On Wednesday, September 25, I attended a meeting of the Redlands Airport Association at the Redlands Airport. Captain David Zamiska of the UPS (United Parcel Service) Flight Operations Technical and Safety team gave a 30-plus minute discussion pertaining to the UPS Airlines effort to establish at San Bernardino International Airport, (a) a "visual approach" for Runway 24, (b) an RNAV (RNP) instrument approach to Runway 24, and (c) an RNAV (RPN) approach to Runway 6 – suitable for their larger 767 cargo jets; and in a few years, suitable for 747 and 777 cargo jets.

UPS is developing 3 instrument approaches, 1 visual approach, and 2 departure procedures for SBD. The handouts (attached) they shared included a plotting of the draft visual approach and the two draft instrument approaches (RNAV Z Rwy 24 & RNAV X Rwy 6). I have asked them for the third instrument approach and 2 departure procedures. The visual approach is a company procedure. The instrument approaches will be public. Their use will require authorization because it requires certain GPS equipment and training to use the approach. It is realistic to see other operators use the instrument approaches if they are authorized.

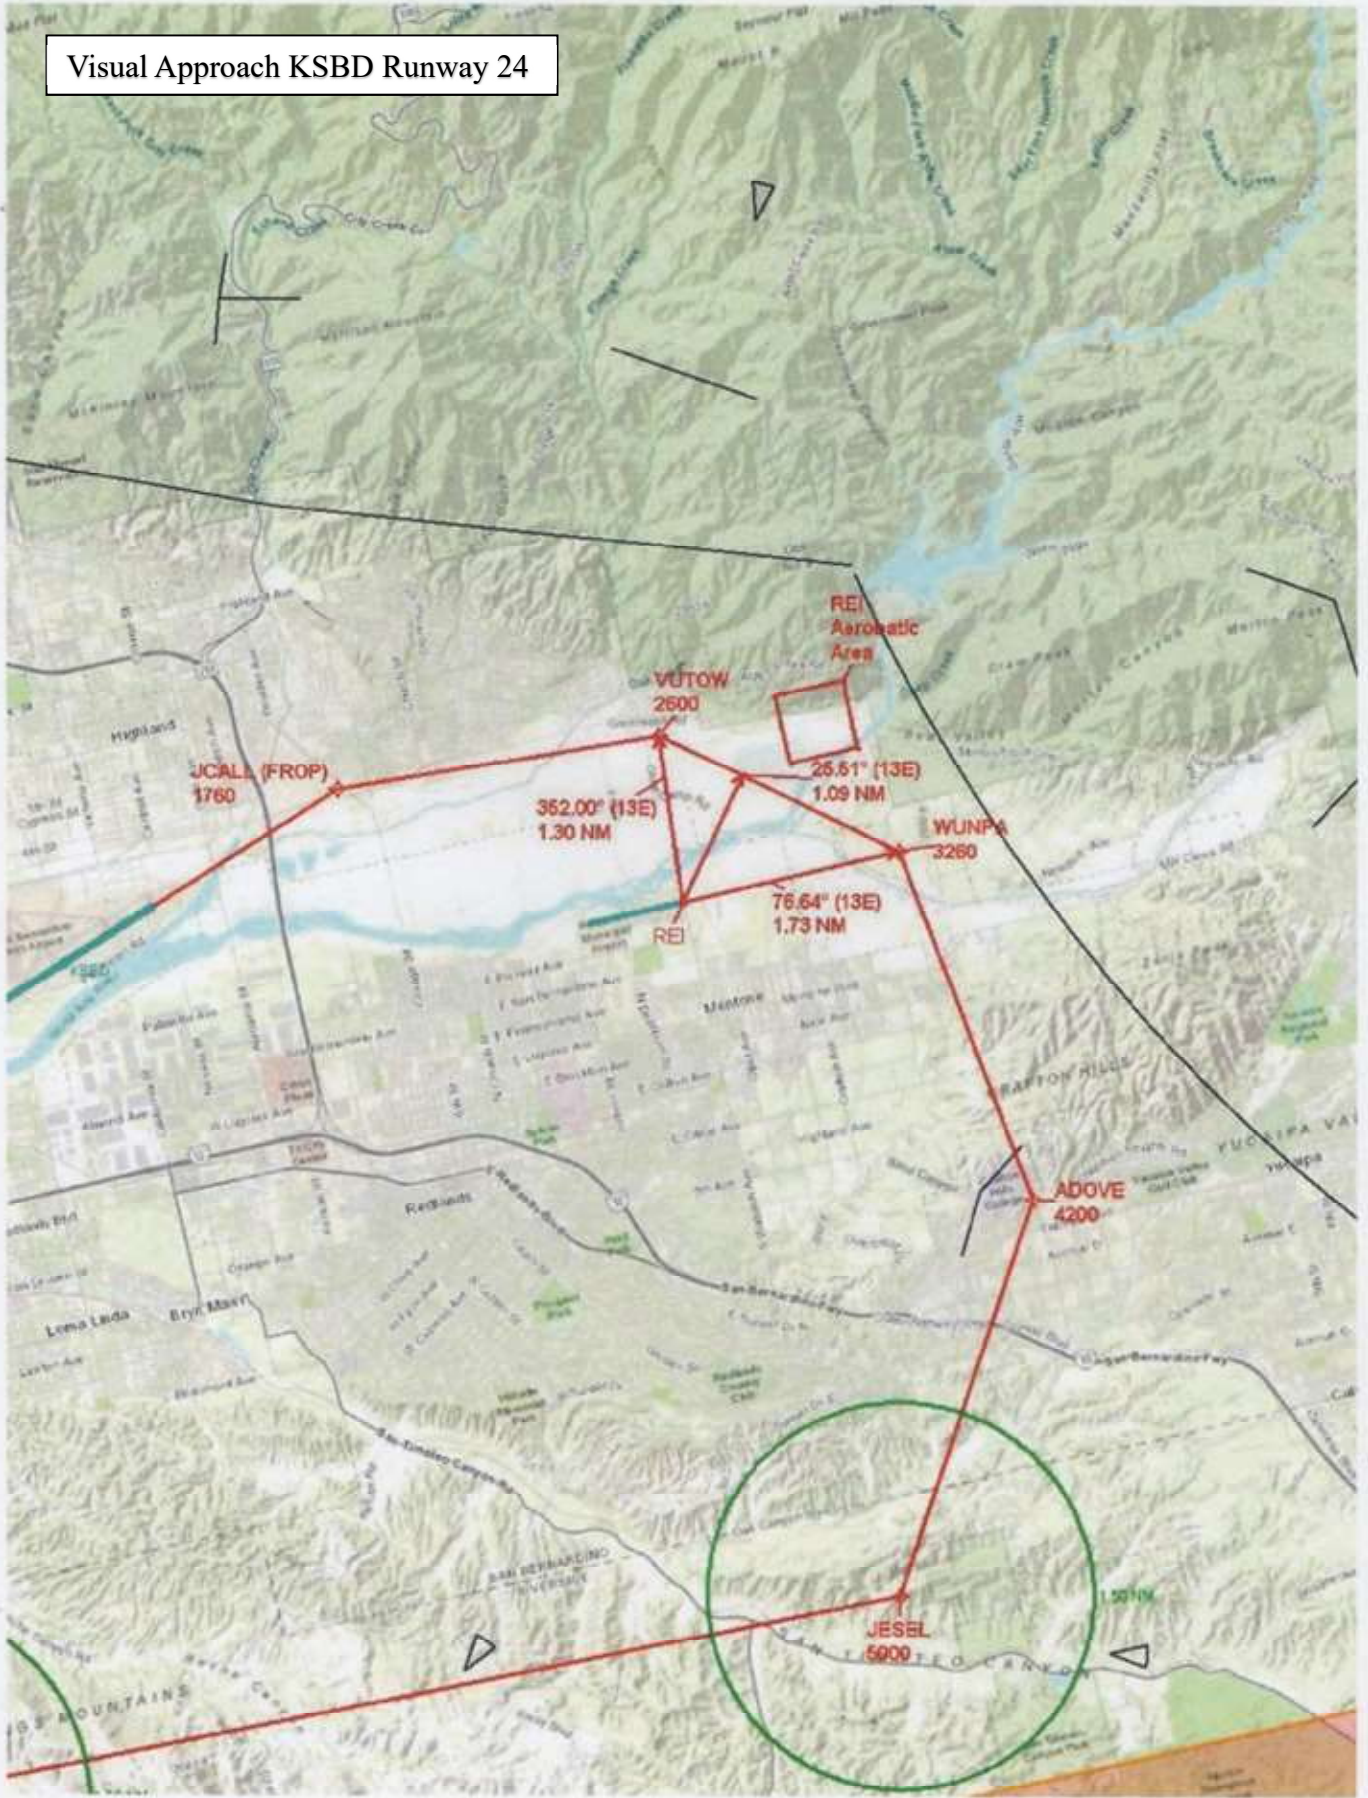
1. The UPS internal visual approach is almost identical to the proposed RNAV (RNP) Z Rwy 24 approach -- although the "waypoint" names are not quite the same. JESEL on the visual approach appears to be CASSE on the RNP plate; and the other visual waypoints are not identified on the RNP plate until reaching JACAL. Captain Zamiska did mention that both all of the charts are still under development and that some of the waypoint names have already changed; or will be changed.

As you review the appended "visual approach", keep in mind that it is for internal UPS use only. It is a draft only. It will eventually take a form similar to the Jeppesen chart formats, but not until the waypoints have been unified and confirmed.

3. All of these approaches must get past the FAA Environmental assessments. Given the experience of the folks in Lake Arrowhead, it is very probable that the people in East Highland (essentially those living just north of Greenspot Road (VUTOW to JCALL on the Visual Chart) will rise up in arms! Most of those people moved to that area due to its solitude and quietness!
4. Zamiska also seemed to imply that while the present approaches are basically to serve the 767's in the UPS fleet ... it is likely that bigger jets (747 and 777) will begin using these approaches in two to three years. Apparently, there is significant growth intended for the San Bernardino Cargo operations by UPS and/or (he indicated) Amazon. He did not discuss FedEx, although FedEx and Volga-Dnepr also have cargo operations KSB.

One "casual" note -- one of the folks at the Redlands Airport meeting was flying in the pattern at Redlands (including at least downwind segment) as a UPS 767 was flight testing the visual approach to San Bernardino. That pilot noted that he was above the 767 on visual approach to San Bernardino while downwind at Redlands. He stated that he was well inside of the 767 and could easily see the 767 as well.

Zamiska made the point that the intent of the visual approach (and RNAV (RNP) Z 24 approach) is to be well outside the Redlands pattern area and below the Redlands downwind altitudes to ensure against wake turbulence.

Still, as a pilot, I would have some concern if I were in a high pattern at Redlands, particularly as I turned base -- since the jets could be flying counter-direction and descending through my altitude as I turned that base leg. However, assuming Runway 26 at Redlands was in use, the winds would be blowing any wake turbulence from a 767s up the canyon and away from the base leg ... great in theory, but reality is another exercise.

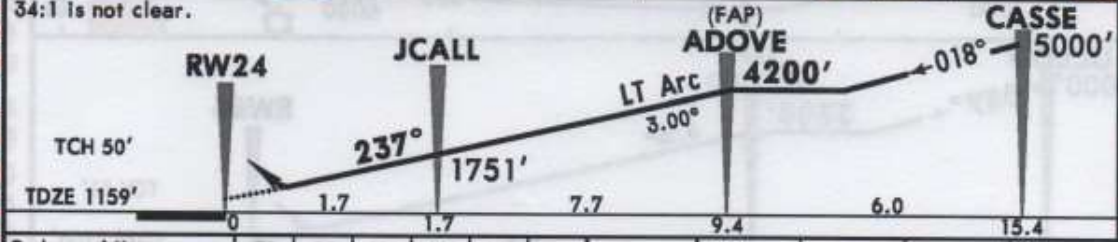
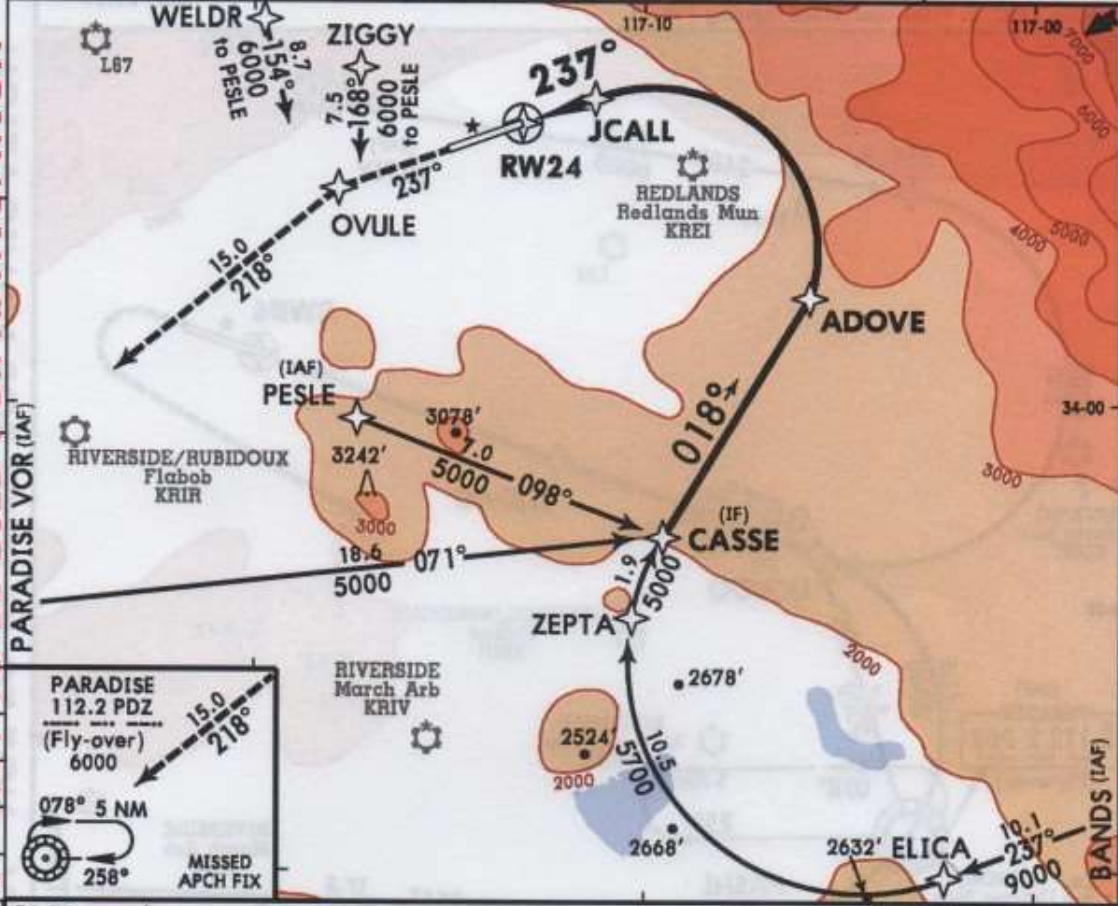
6. However, the RNAV (RNP) Z to Runway 24 DOES originate via ZIGGY waypoint (which is part of the EAGLZ approach), descending to 6000' over Lake Arrowhead enroute to PESLE waypoint. The WELDR intersection initial approach waypoint that also leads to the PESLE waypoint appears to be west of the Lake Arrowhead area -- but I would need to fly that to be sure.

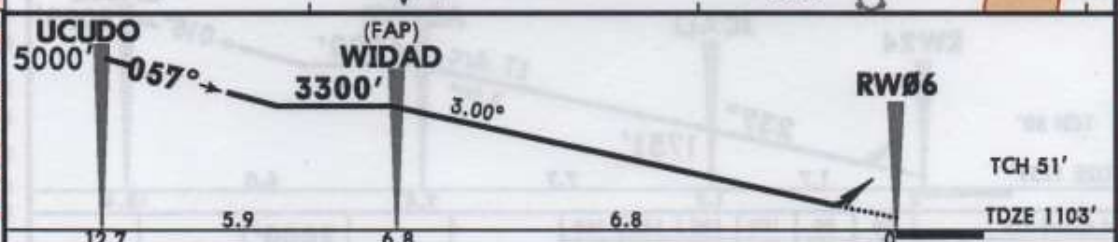
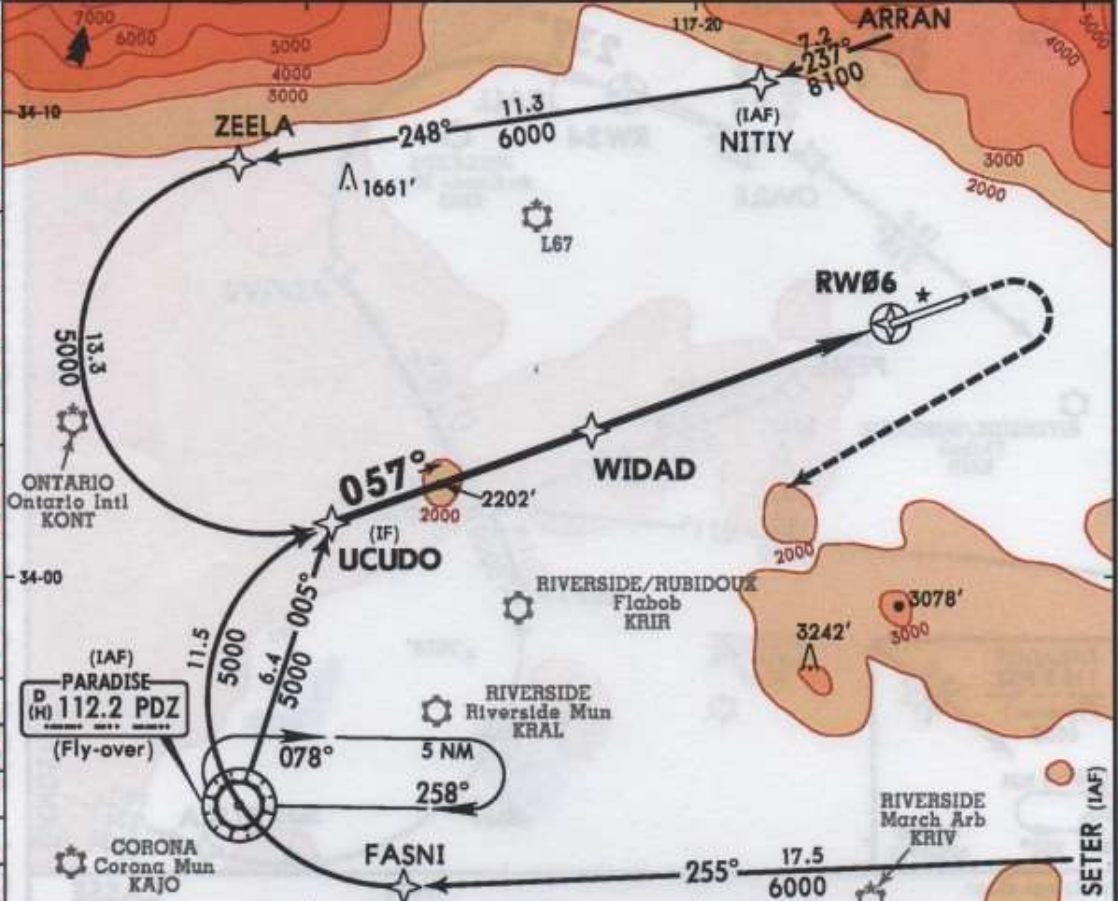
2. The RNAV (RNP) X Rwy 6 is almost the same as the RNAV (GPS) Rwy 6 approach ... but it added the NITTY waypoint approach for airplanes approaching from the north or east ... and the published altitudes are 1000 feet higher at the Initial Fix (IF), UCUDO, and a slightly higher DA (Decision Altitude) at 1409 feet (306 feet above ground) versus 1353 feet (250 feet above ground) for the GPS approach. There are slightly higher visibility requirements as well (1 mile vs. 3/4).

It is worth noting that the Los Angeles FLY chart depicts a VFR traffic corridor through this area below 9500' ... and the UPS chart has their jets descending from 8100 feet down to 6000 feet in this same airspace. But the jets are big ... so most VFR pilots should see them (although wake turbulence could still be an issue).

5. While not particularly relevant to the Redlands group but certainly relevant to the Lake Arrowhead folks, the proposed UPS RNAV (RNP) X approach to Runway 6 does suggest that the UPS flights will be flying into KSBD over the ARRAN waypoint (which is a waypoint on Victor 8 just past over Heap's Peak) ... east of the currently impacted Lake Arrowhead area . Whether the FAA would opt to "join" UPS flights via the current EAGLZ approach is something that only the FAA would know.
